Access Compliance Report

Public Rights-of-Way

(Pedestrian Signals)

Intersection ID: N/A	Main Street:	Cross Street: N/A	Location: N/A
ADA ID: B602E20A79F3	Signal Type: Two Push Buttons-APS	Overall Compliance: No	Severity Score: BTN 1:N/A BTN 2: N/A No BTN: N/A
Codes/Mitigation Info/Possible Solution		Field Measurements/Component Compliance

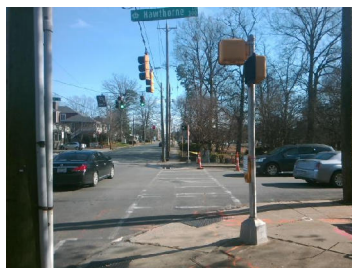
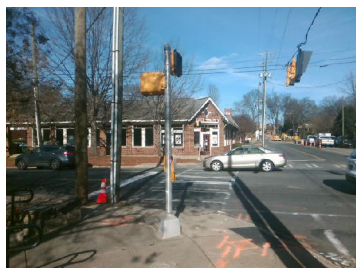
PROW/ADA: TMUTCD 4e.08, R404.2, R404.3,

Yes	B 1 Clear Xing Direction?	ClearlyMarked	Yes	B 2 Clear Xing Direction?	ClearlyMarked
	B 1 Crossing Direction	To SE		B 2 Crossing Direction	To NE
Yes	B 1 DistanceTo XWalk (in)	0.0	Yes	B 2 DistanceTo XWalk (in)	0.0
No	B 1 DistanceTo Curb (in)	82.0	No	B 2 DistanceTo Curb (in)	82.0
Yes	B 1 Diameter (in)	2.0	Yes	B 2 Diameter (in)	2.0

Possible Solutions: Replace Signal Push Button With APS Button on New Post. Remove & Relocate Sign.
